UNIVERSITY OF KENTUCKY
Purchasing Division

INVITATION FOR BIDS
CCK-2602-22
ADDENDUM # 2
02/01/2022

ADDENDUM #2 – BID PACKAGE #2

Project Title: __#2551.0 Pavilion H – 3rd Floor Behavioral Health - Bid Package #2 - Fit-Out__

A4.3.A.2

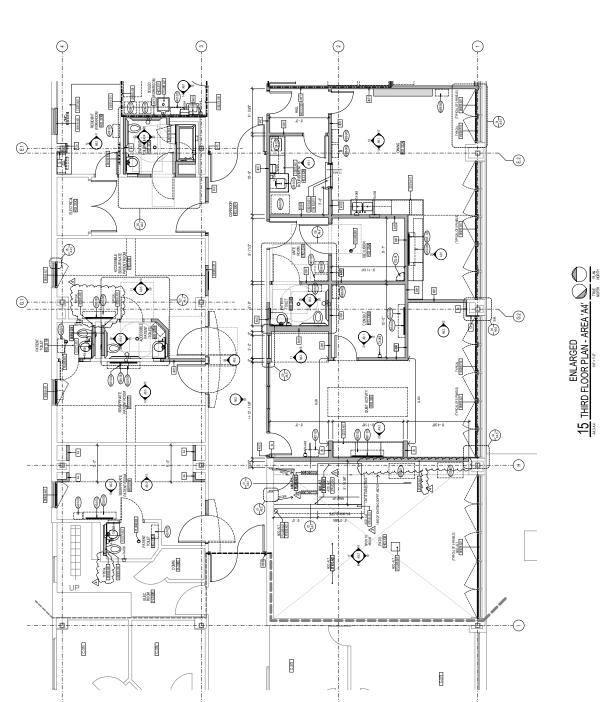
2.08   **Reference:**   A4.A.1 through A4.1.A.4 - Enlarged Floor Plans

D. **Clarification:**   Added keynote 092900.A08 to 'PROVIDE DRYWALL AT LOCATIONS WHERE CEREAMIC TILE WAS REMOVED DURING DEMOLITION, TYPICAL ALL LOCATIONS WHERE OCCURS'. Reference updated plans for locations.

E. **Clarification:**   **Base Bid –** EIFS wall to sit on existing curb where existing storefront system is located. Keyed in curb extension has been revised to be part of the Add Alternate. Keynote 035416.A03 will be removed as part of Base Bid and become part of the Patio Add Alternate. This will keep place any removal of the Patio slab as part of the Add Alternate related to the Patio work.

Add Alternate – to include keynote 035416.A03 to remove and replace the portion of the patio where Structural curb extension occurs as part of Add Alternate.

F. **Clarification:**   **Base Bid -** EIFS wall at patio, provide 3 5/8" structural stud with 3" min closed cell spray foam insulation in lieu of thermal wall insulation. Wall to sit on existing curb. Reference revised Architectural Section 02/A8.1 and Structural Drawings for Revisions to framing at EIFS wall

Add Alternate - EIFS wall at patio, provide 6" Structural stud with standard wall insulation and keyed in Structural curb as noted in revised Structural Drawings.
